Final FD Report

RP7 Price Control Engineering Support & Asset Management Advice

Utility Regulator for Northern Ireland

16 October 2024

Figure 2 Comparison of Model Outputs - 33 kV Replacement Volumes

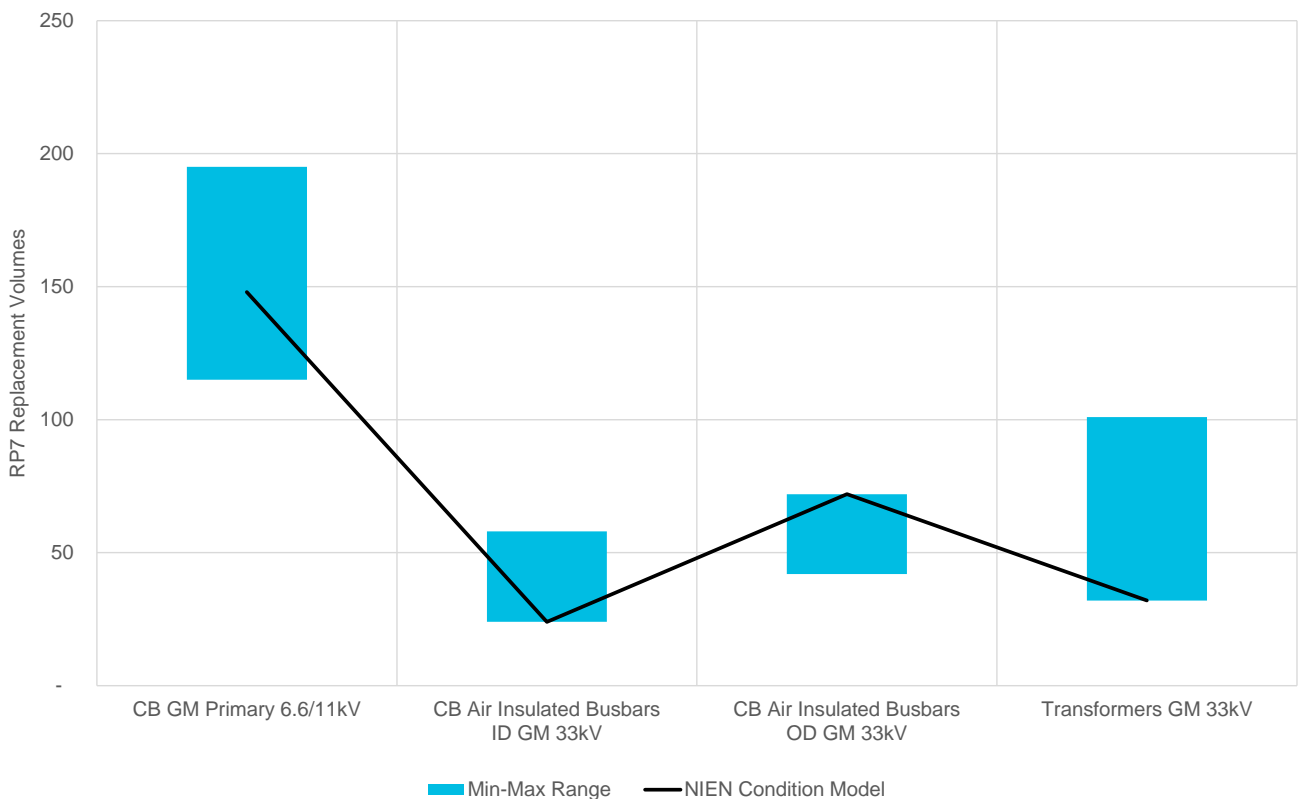
For the 33 kV Outdoor CB replacement volume, the NIE Networks condition-based model produces the highest replacement volumes for RP7. This higher volume is driven by a specific type-defect (SWS EO1 type), described above for which NIE Networks has investigated repair options for the oil filled 33 kV circuit breaker but with no viable solution being identified. We remain satisfied that the replacement volumes for these asset categories are reasonable for RP7.

Figure 3 Distribution Primary plant – Unit cost assessment

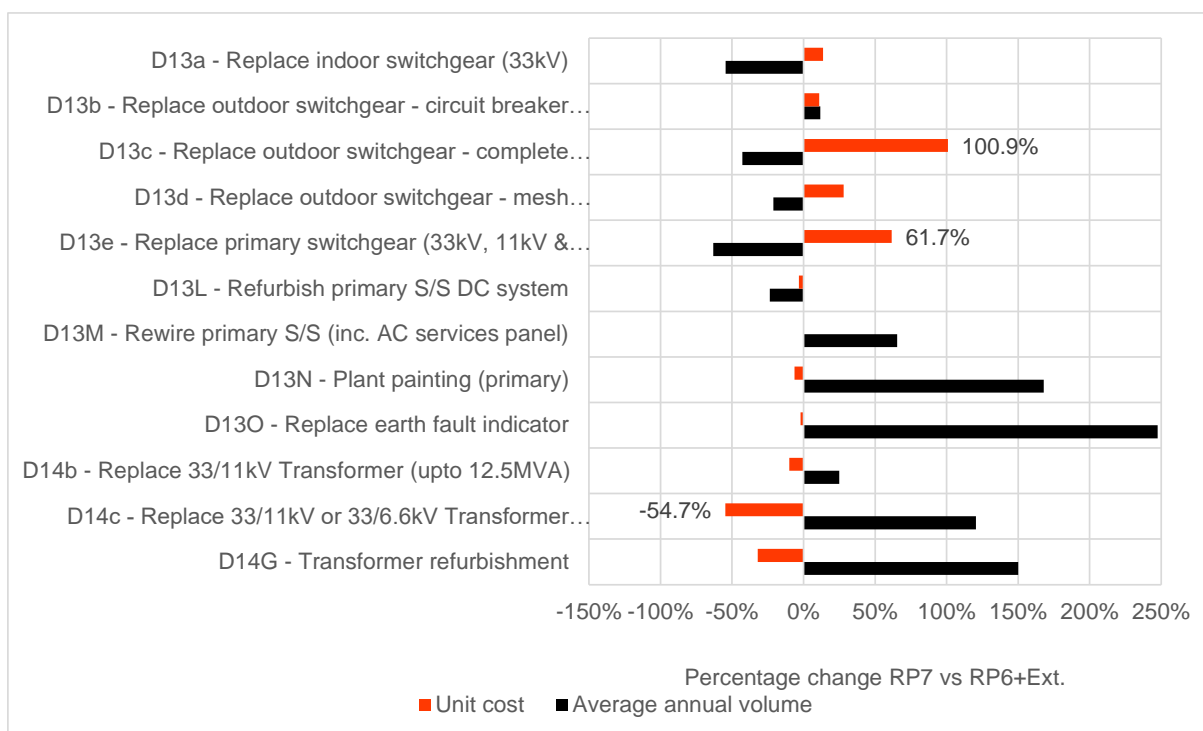
From Figure 3 it is evident that the requested unit costs for the D13c and D13e expenditure categories correspond to the greatest percentage changes. In addition, NIE Networks’ query response on unit costs¹³ indicates the assessment carried out by NIE Networks to apply adjustments to the March 2022 outturn unit rates. These comprise adjustments to account for:

Figure 4 D13o – cumulative NPV of options presented by NIE Networks in its CBA

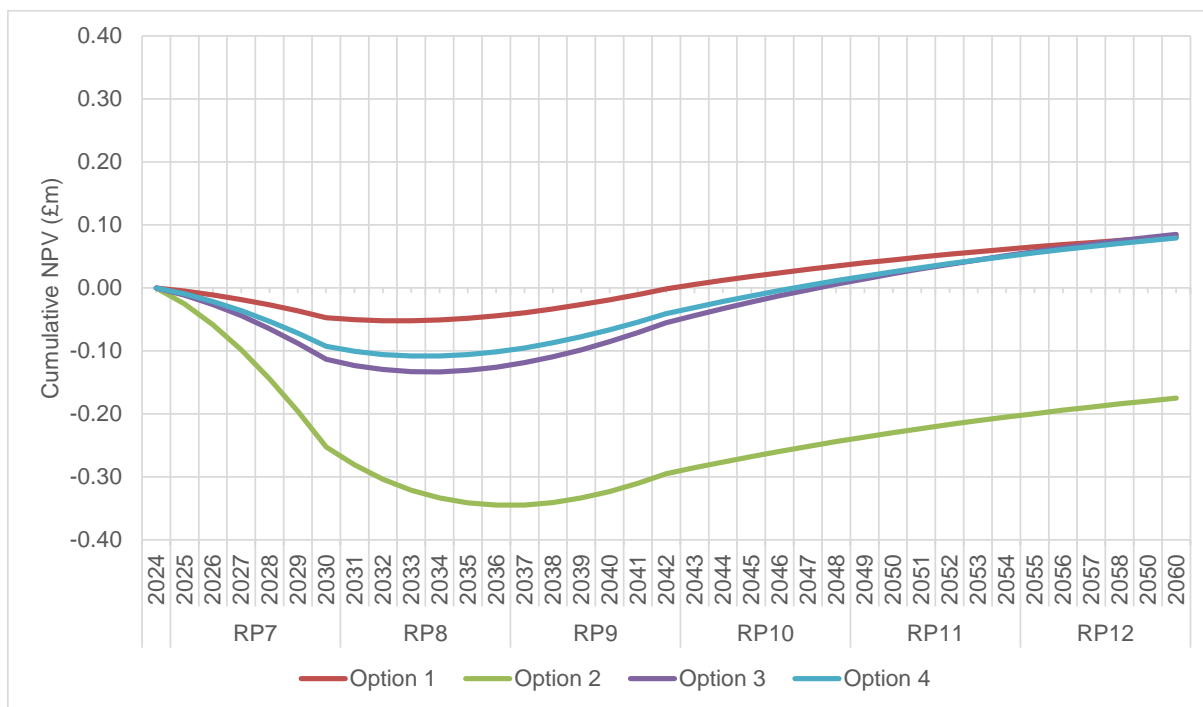
It can be seen that, based on the modelled costs and benefits, none of the options achieve a positive cumulative NPV until 2042. As presented, the CBA appears to support the approach to minimise up front costs by adopting basic EFIs. However, GHD acknowledges that smart EFIs installed in strategic locations are expected to provide benefits (including ‘reduction in post-fault maintenance and engineering labour time... to achieve efficiency savings against indirect costs from these activities’).

Figure 5 Comparison of Model Outputs - 11 kV & LV Asset Replacement Volumes

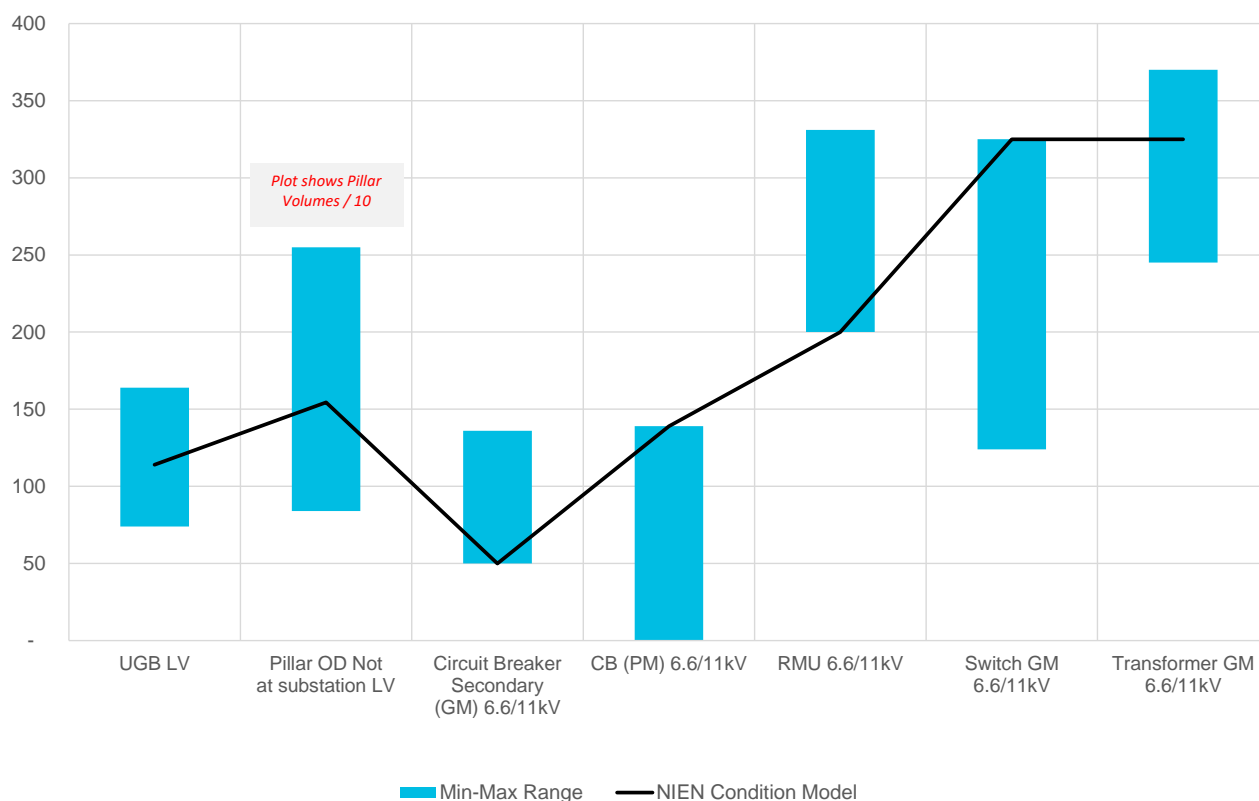
For the 11 kV pole mounted CB replacement volumes (Sectionaliser replacement), the recommended RP7 volumes are based on intervention required to address an identified type defect with the SF6 units resulting in loss of SF6 gas.

For the 11 kV ground-mounted switch replacement volumes, the replacement volumes are included within the work programme for complete substation replacement. The prioritisation of these replacement works is based on detailed condition-based assessment for the NIE Networks distribution substation portfolio, which the age-based survivor model would not factor into the calculation of replacement volumes. We remain satisfied that the replacement volumes for these asset categories are reasonable for RP7.

Figure 6 Distribution Secondary plant – Unit cost assessment

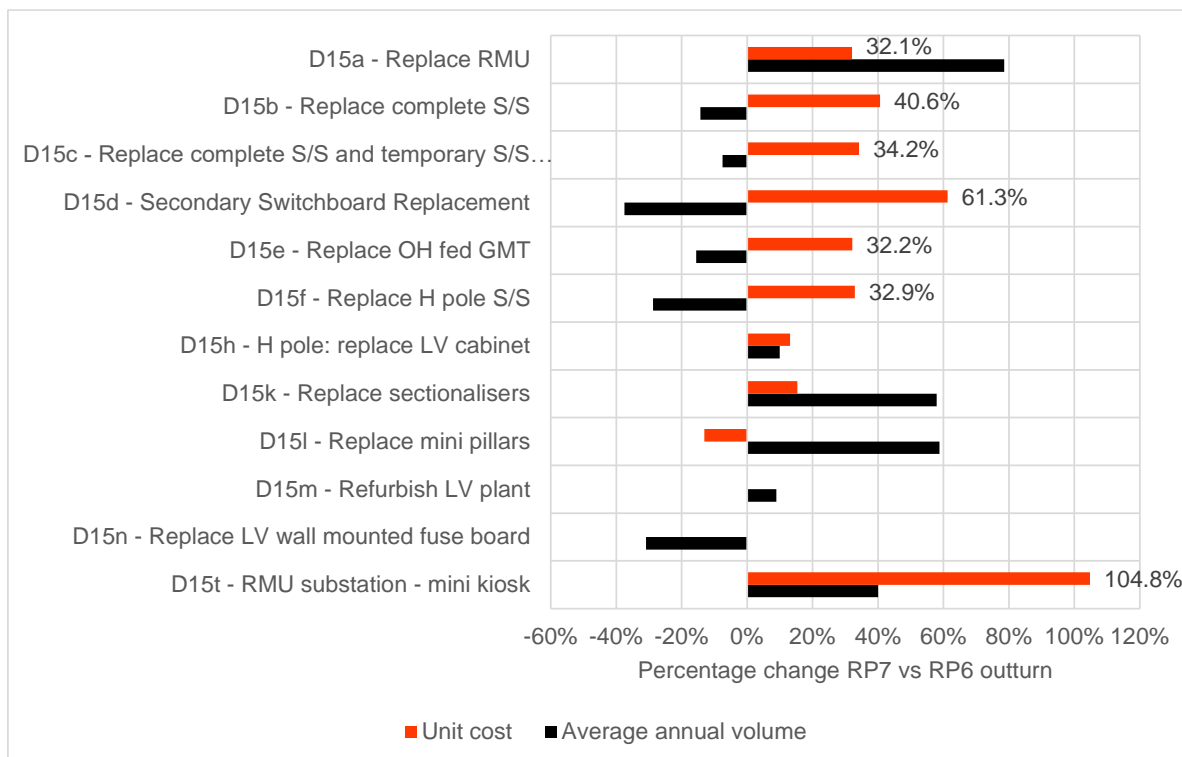
From Figure 6, it can be seen that 7 categories observed unit cost increases, when comparing RP6 outturn to RP7 that were greater than 20%, the largest increase being associated with RMU substation mini-kiosk replacements.

Figure 7 Distribution protection – Condition assessment summary for 33 kV sites (retrofit)

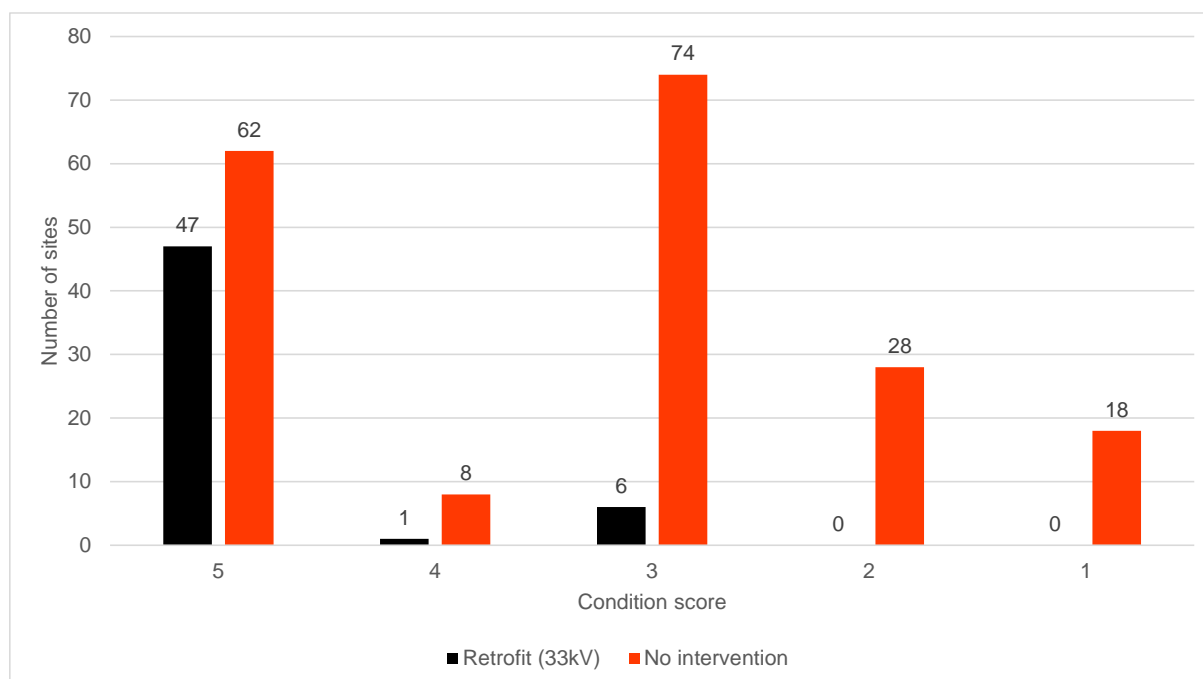
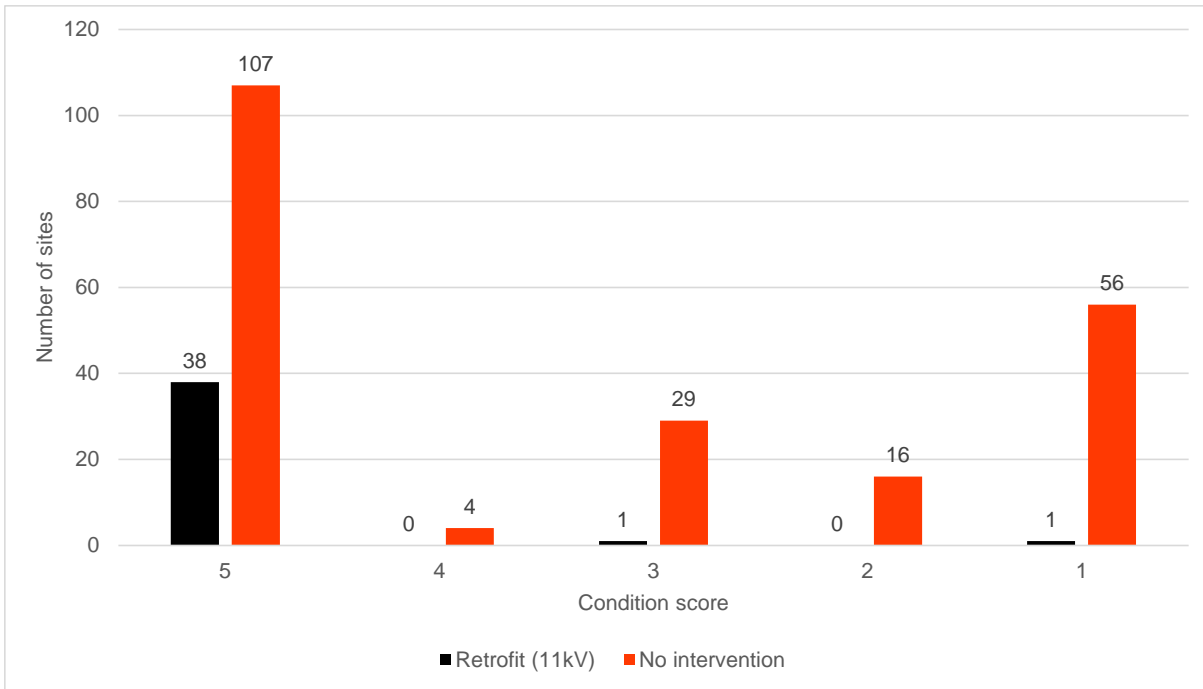
The results shown in Figure 7 and Figure 8 indicate a high population of sites where equipment has been assigned a score of 5 (immediate intervention required).
